NARRATIVE OF REVISION

Project: Irvine Field House
Project Address: 17300 Red Hill Ave. Irvine, California 92614

Subject: Narrative of Revisions
Delta 7 – 04/30/2026

1 ENLARGED MECHANICAL PLAN
1/8" = 1'-0"

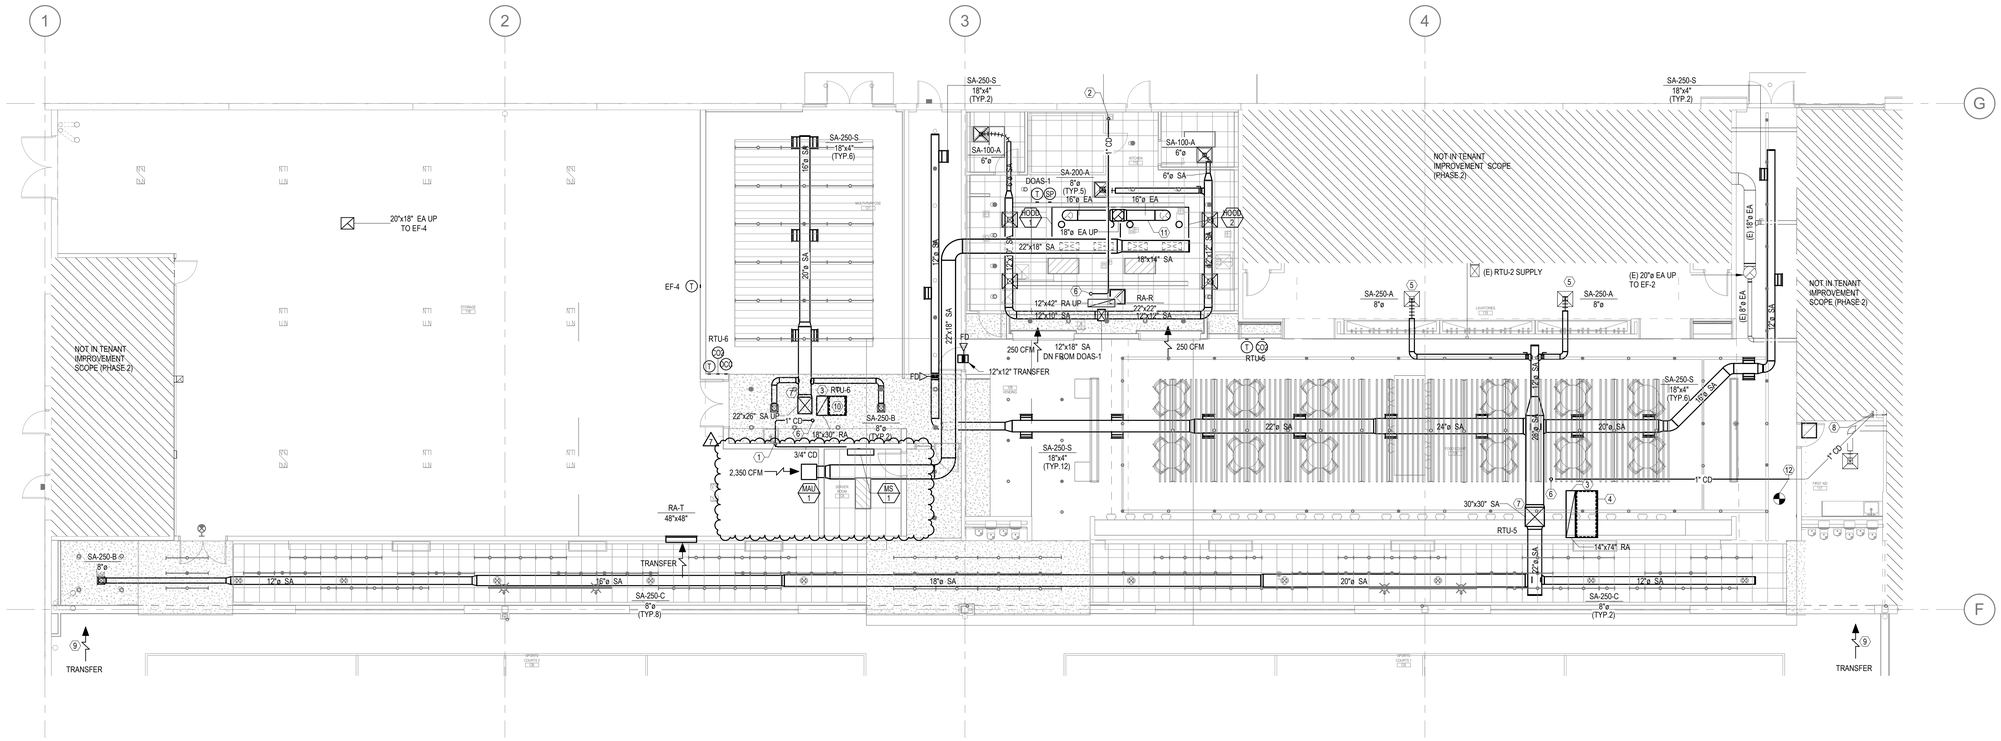
Sheet MT202
- Added Mini-Split (MS-1) to server room. Added condensate to nearest lavatory.
- Removed additional supply ducts and adjusted remaining supply ducts to kitchen hood to 30"x12".

1 MECHANICAL ROOF PLAN
1/16" = 1'-0"

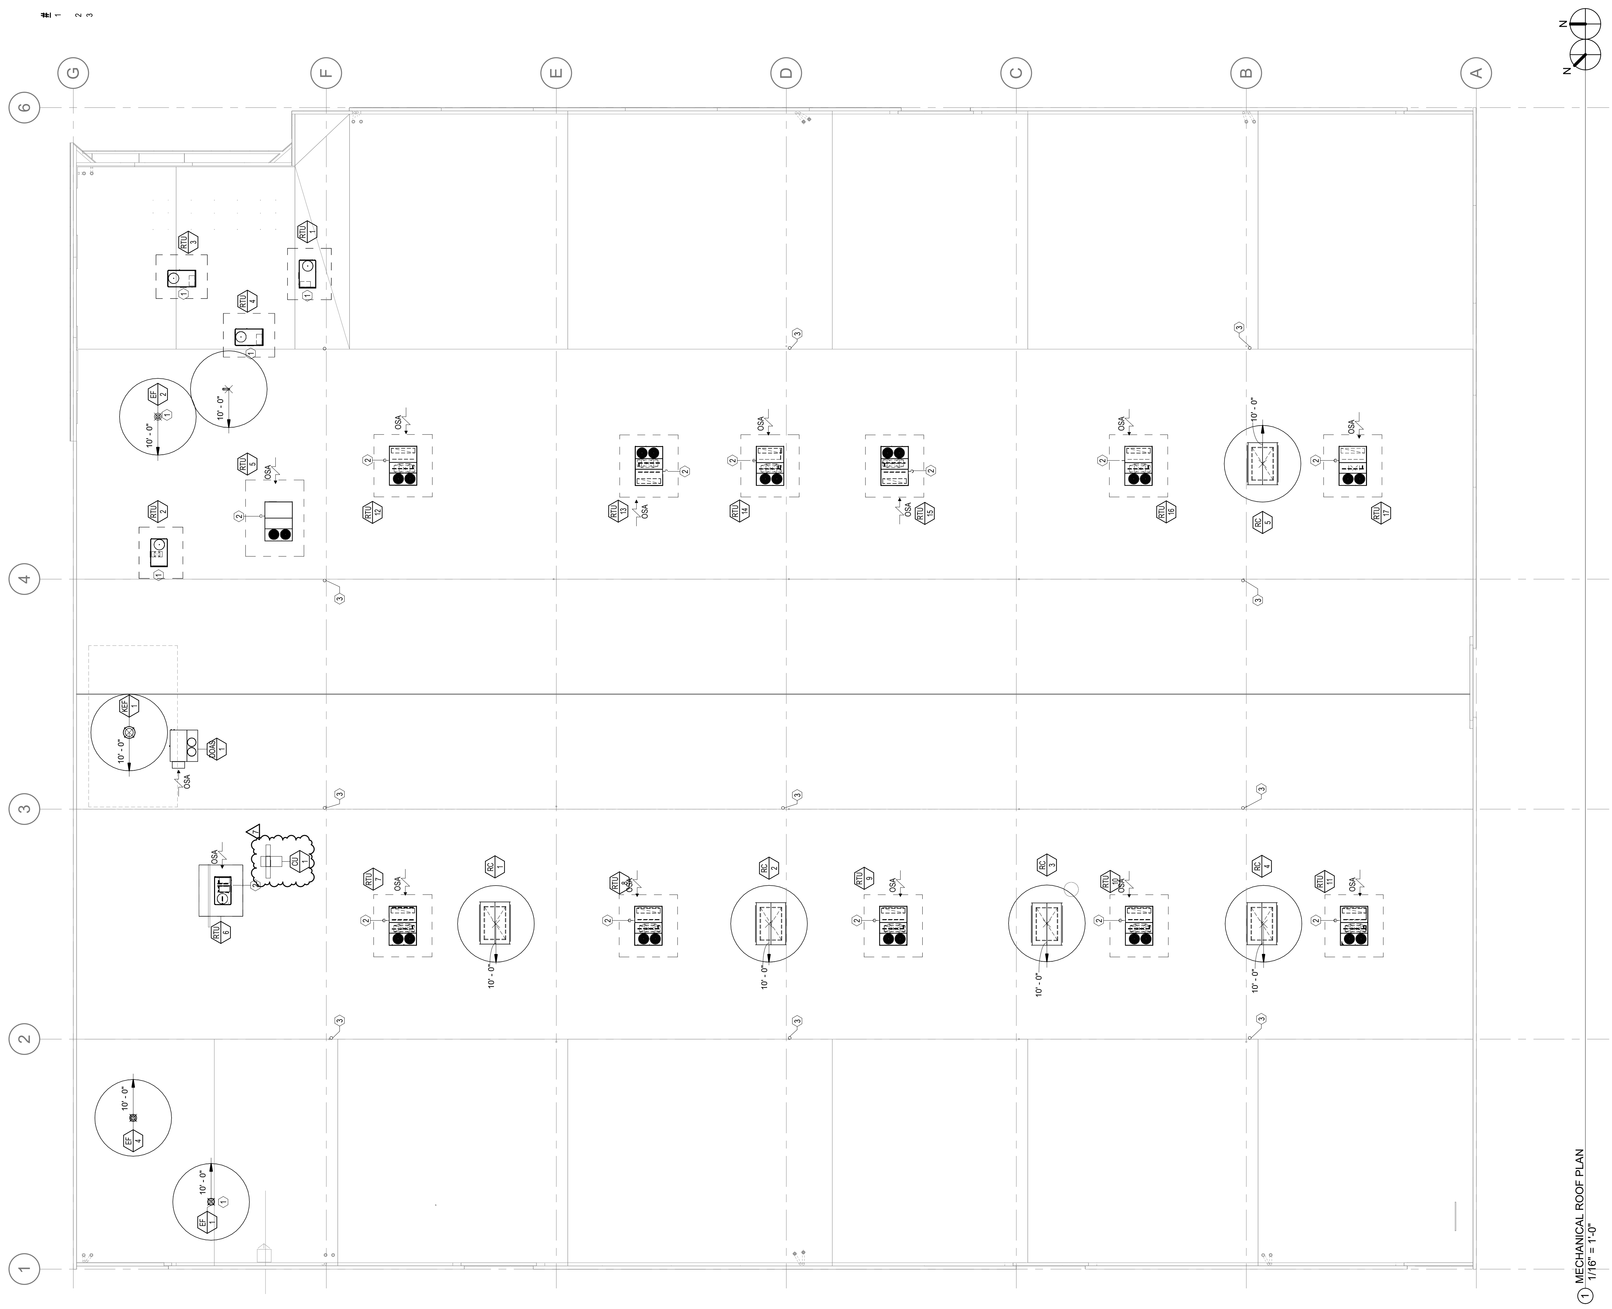
Sheet MT204
- Added CU-1 to roof.

1 PLUMBING ROOF PLAN
1/16" = 1'-0"

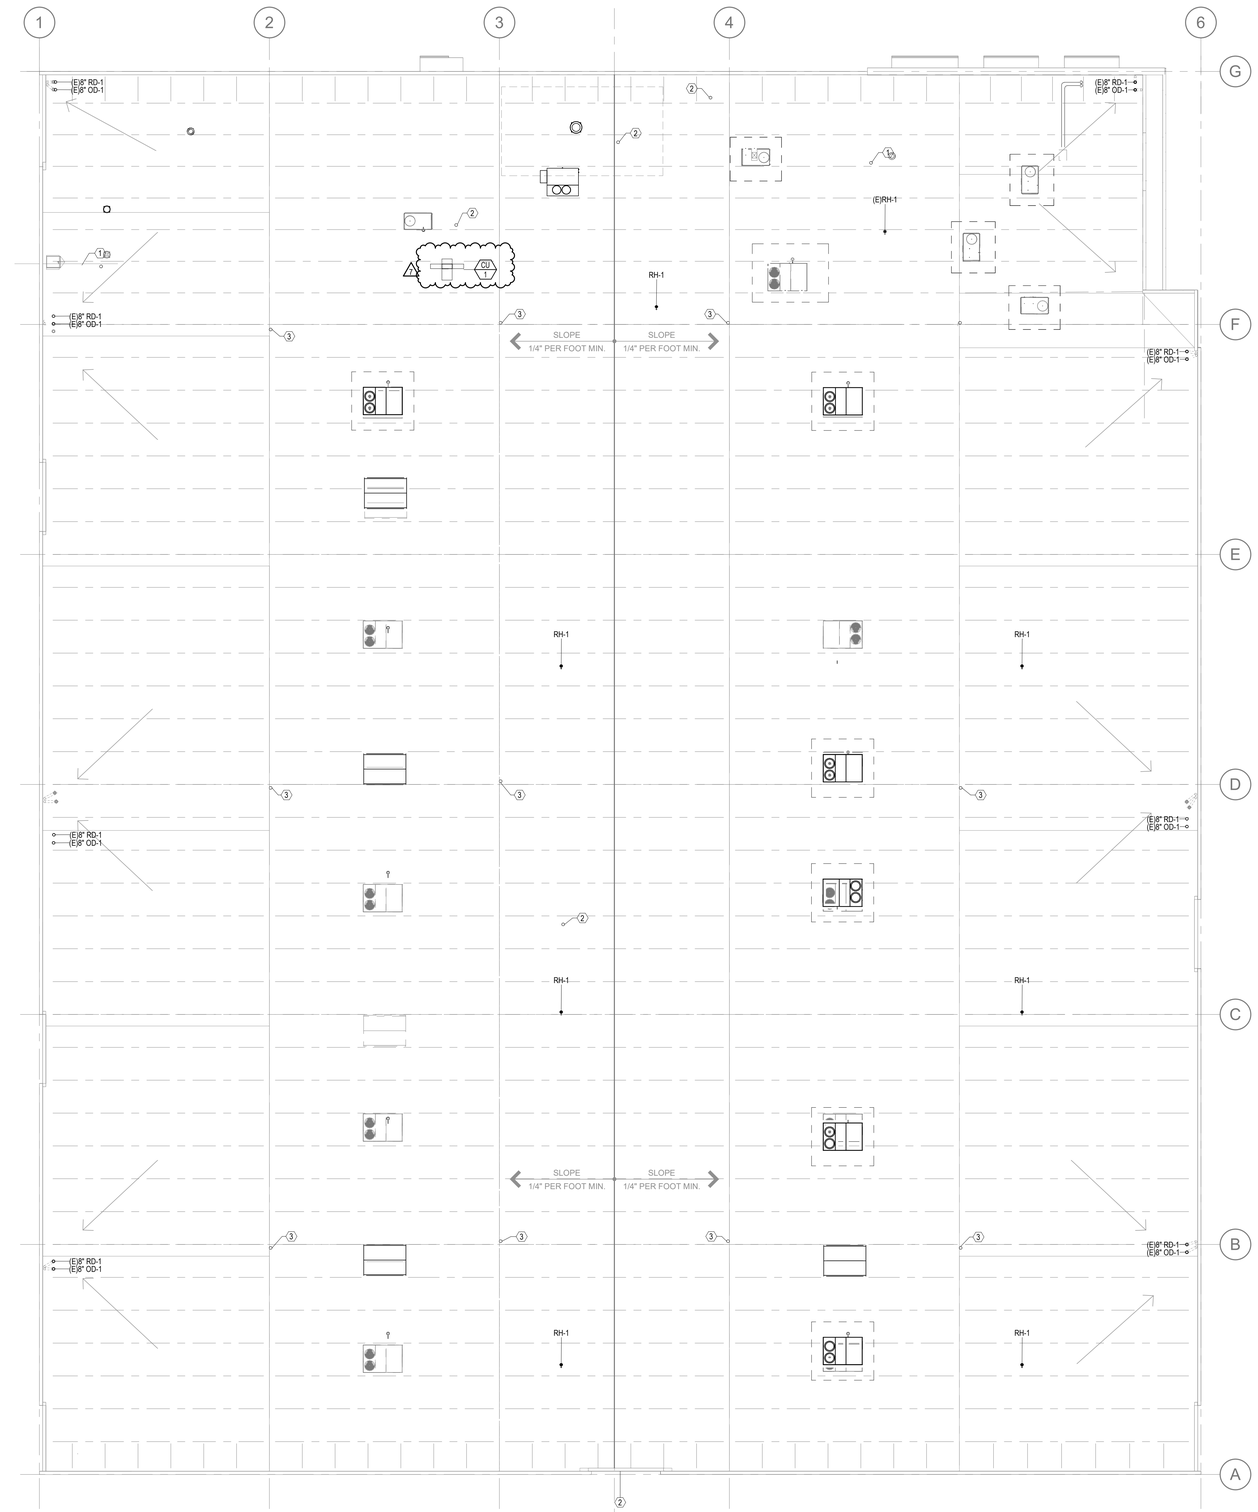
Sheet PT202
- Please see clouded CU-1 to roof.

1 TI ELECTRICAL ENLARGED POWER PLAN
1/8" = 1'-0"

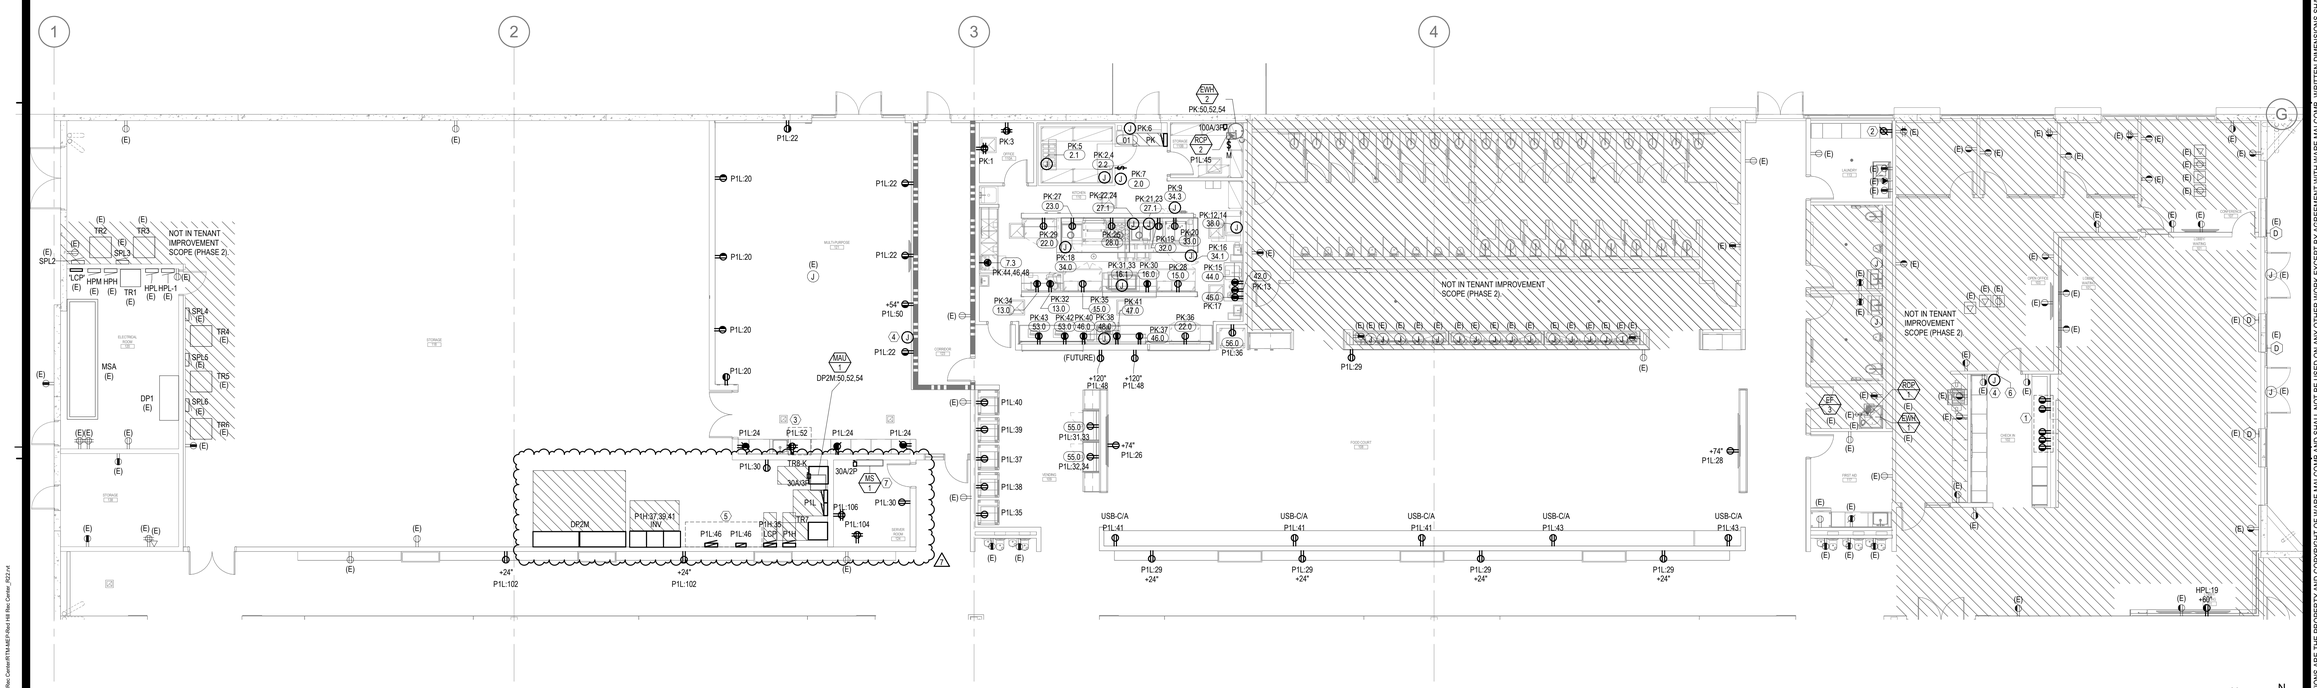
Sheet: ET101
- Relocate Electrical Equipment to the west at the corner of the 'STORAGE 118'
- Add Receptacles to SERVER ROOM 124'

1 TI ELECTRICAL ROOF PLAN
1/16" = 1'-0"

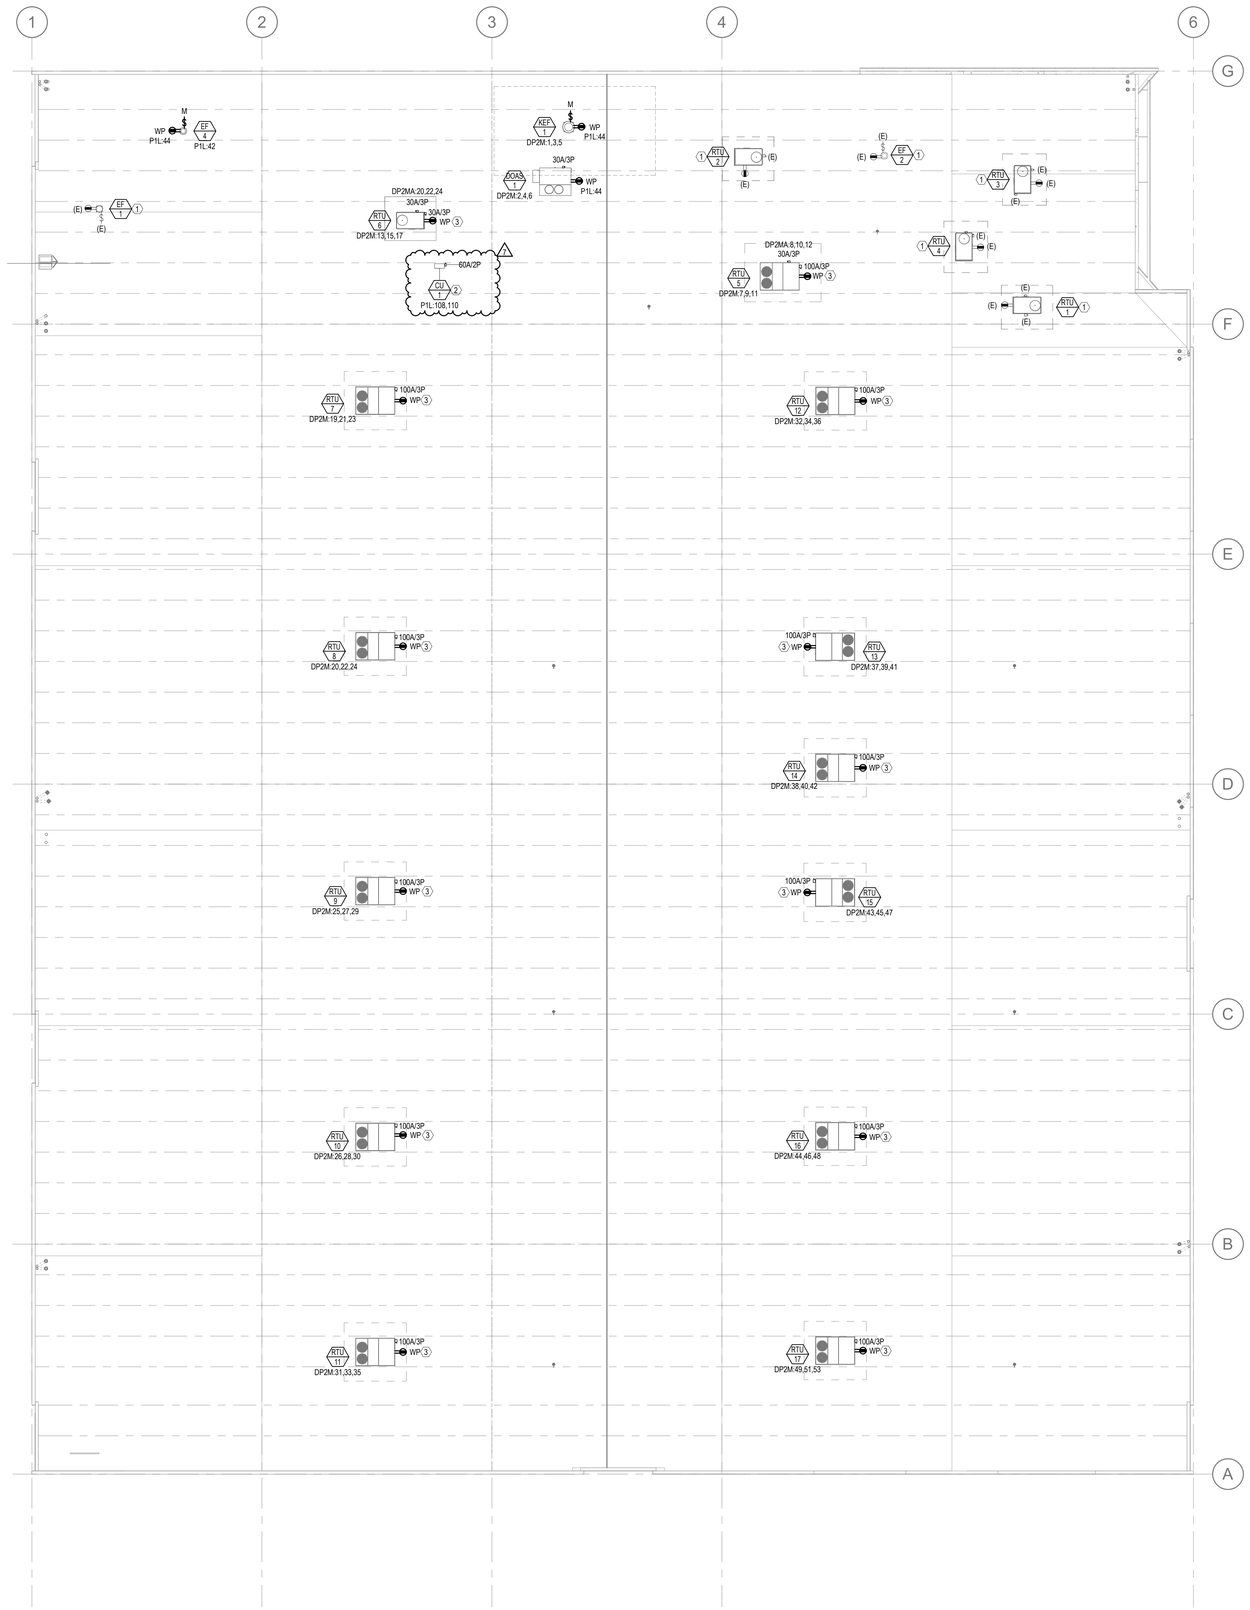
Sheet: ET102
- Add power to CU-1 on ROOF

1 TI ELECTRICAL ENLARGED LIGHTING PLAN
1/8" = 1'-0"

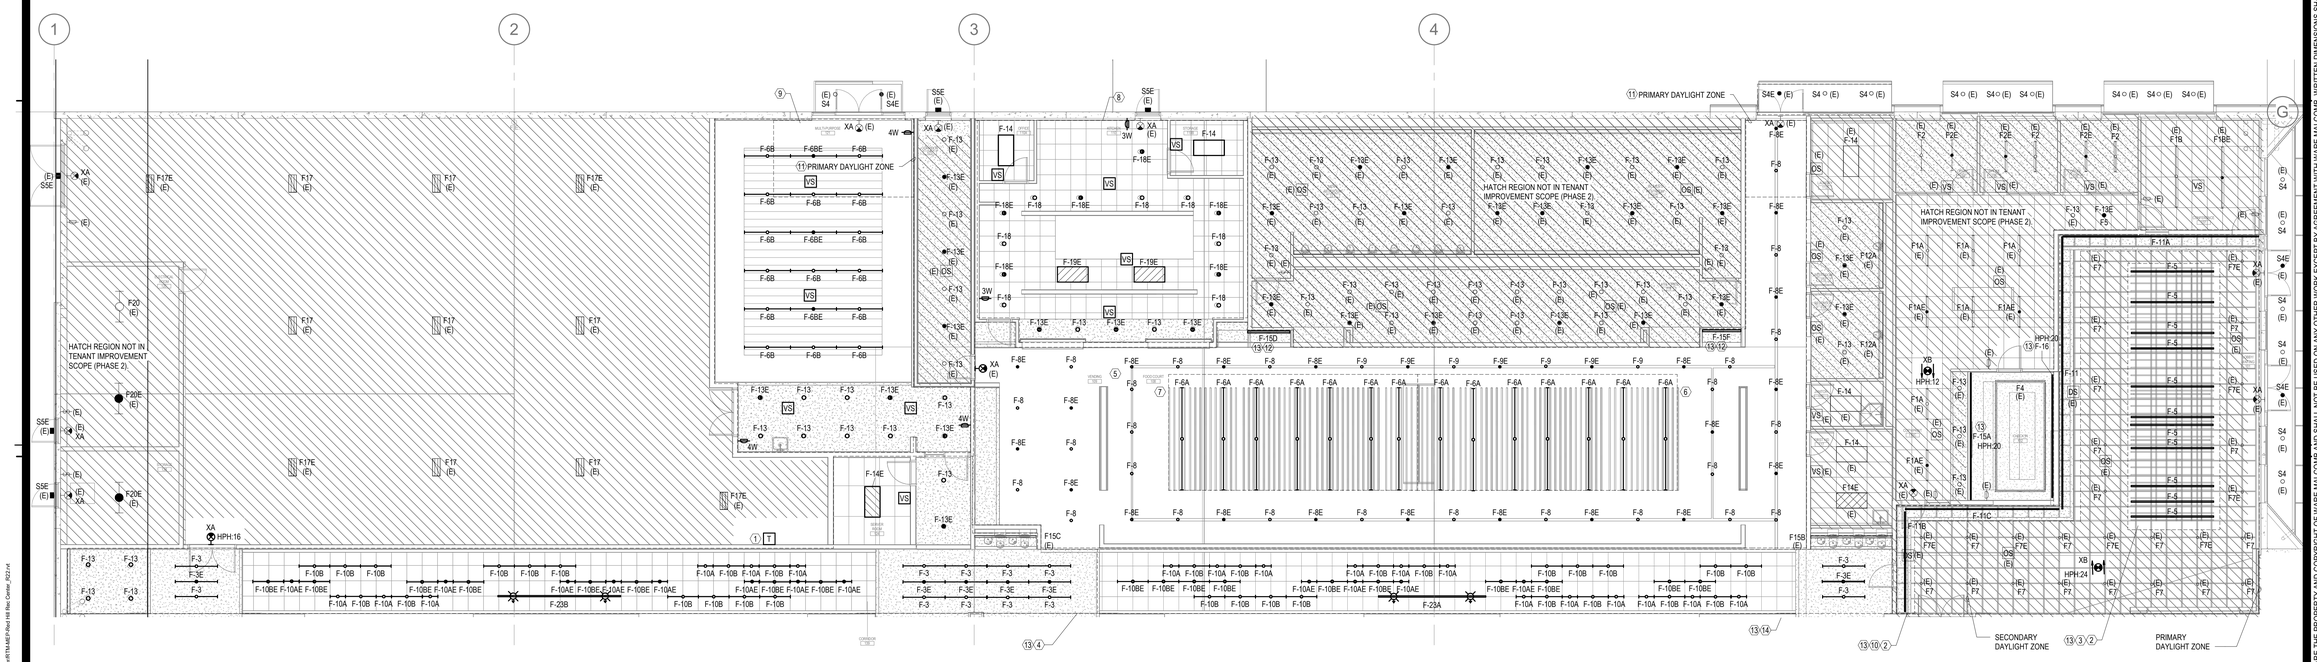
Sheet: ET201
- Add Lighting to SERVER ROOM 124'
- Delete (1) Lighting fixture in 'STORAGE 118'
